First Technology Safety Systems

Flex PLI Catch Rope Bracket Proposal

20 April 2010

4 Point Catch Rope Bracket Proposal

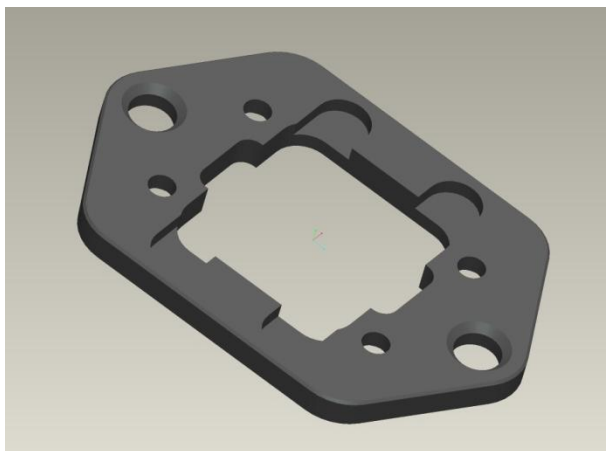
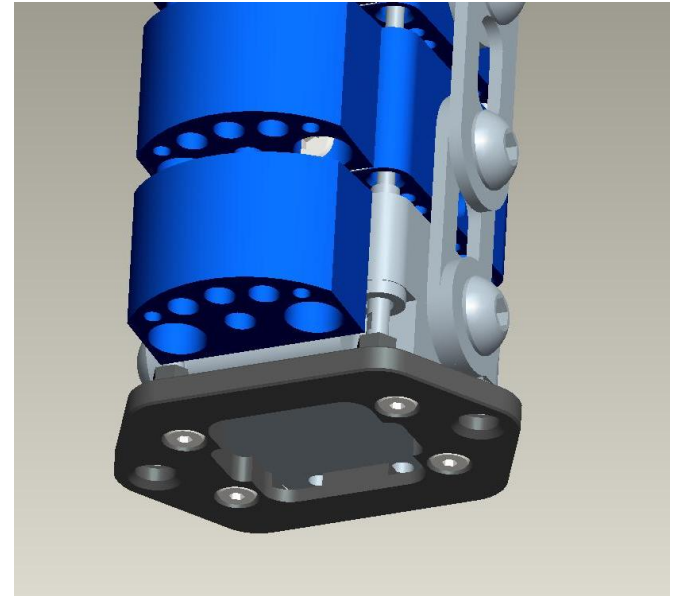
Ø9 rope
holes

Replaces current end protective covers
Weight 13 grams heavier than covers
Proposal currently being reviewed by TUV
Material high strength 7075 aluminium
6 mm thick

Notification of new shim thickness

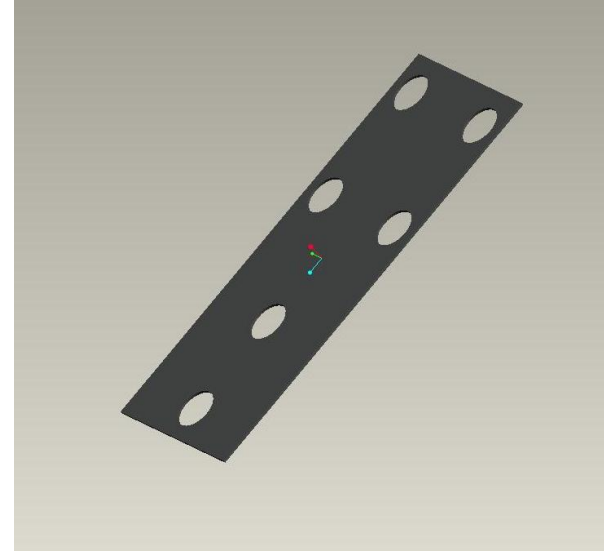
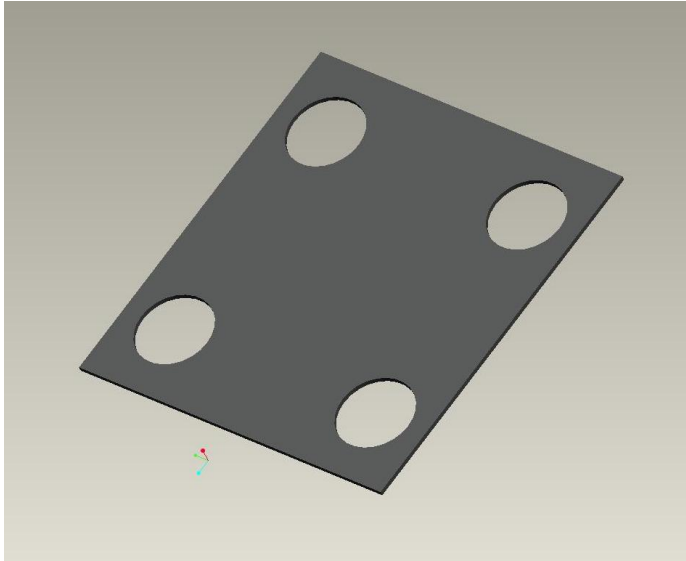
Current segment fit is fine tuned with 0.05 mm thick shims
Will have 0.1 and 0.2 mm thick shims to reduce number of
shims and help handling
